ARKANSAS NUCLEAR ONE, UNIT NO. 1

AMENDMENT TO FACILITY OPERATING LICENSE

ARKANSAS NUCLEAR ONE, UNIT NO. 2

Amendment No. 193
License No. NPF-6

Figure 3.11-1

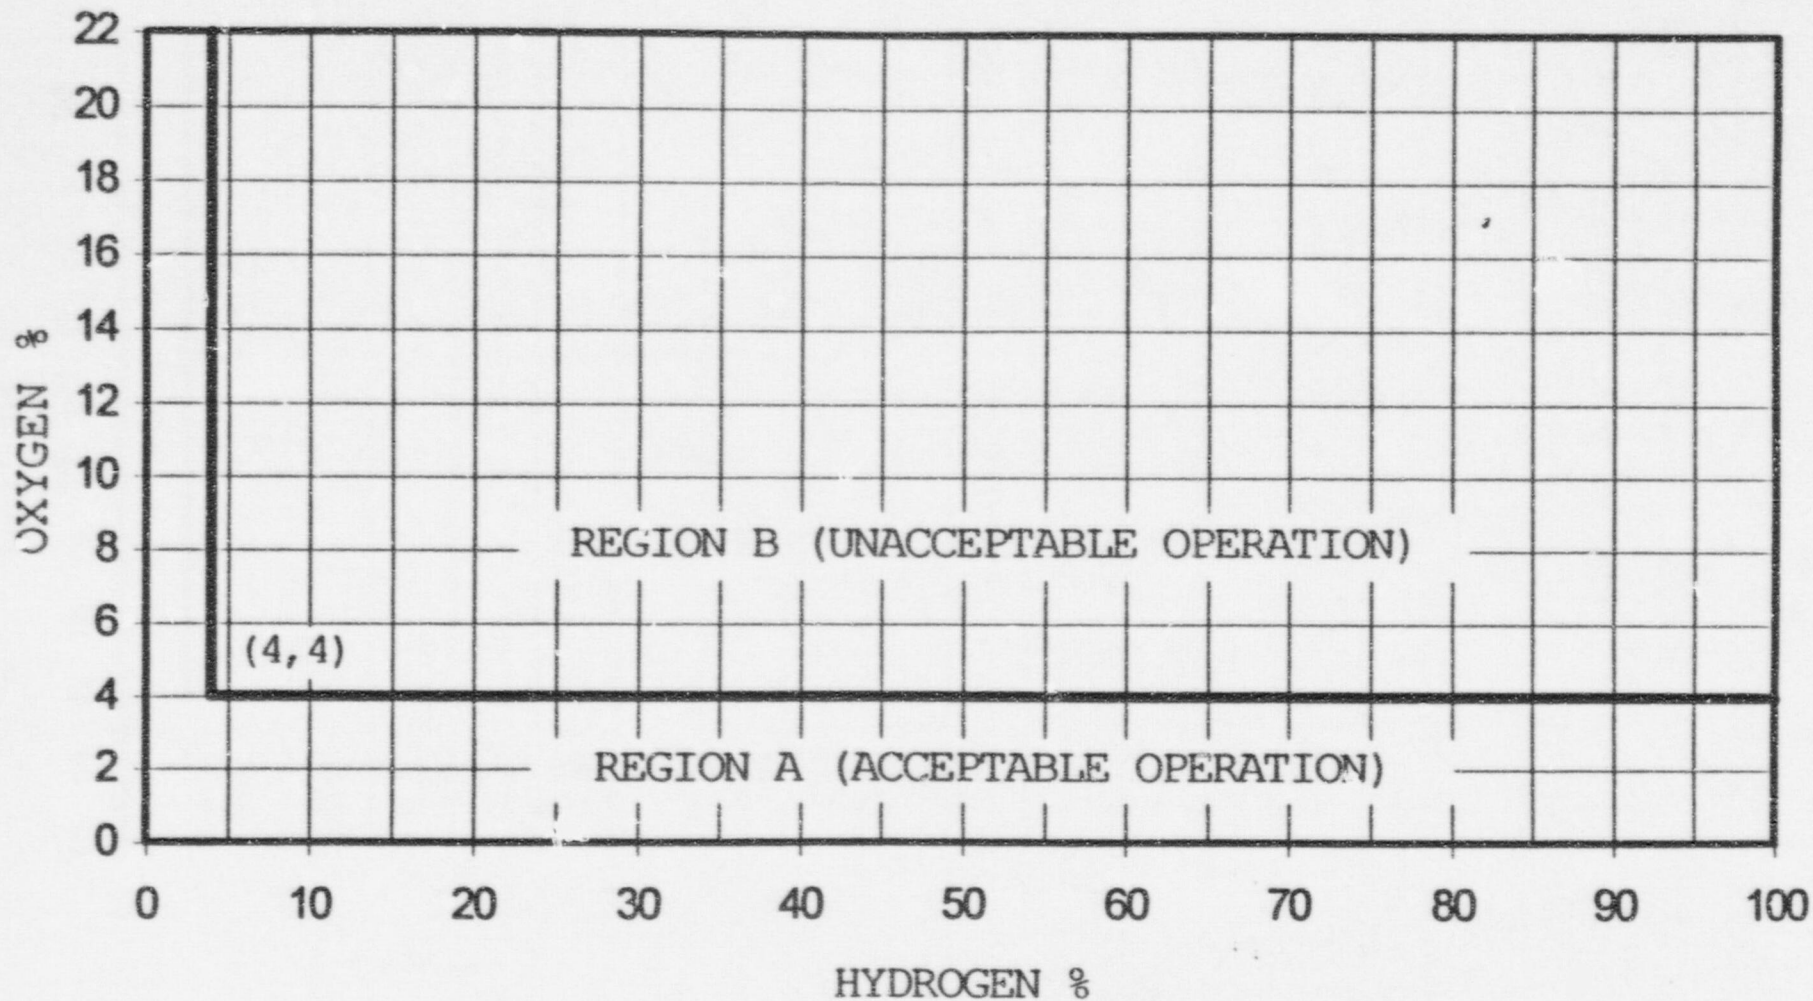
3.11.3 The concentration of the hydrogen/oxygen shall be limited in the waste gas storage tanks to Region "A" of Figure 3.11-1.

- a. When the concentration of hydrogen/oxygen in the waste gas storage tanks enters Region "B" of Figure 3.11-1, corrective action shall be taken to return the concentration values to Region "A" within 24 hours.
- b. The provisions of Specification 3.0.3 are not applicable.
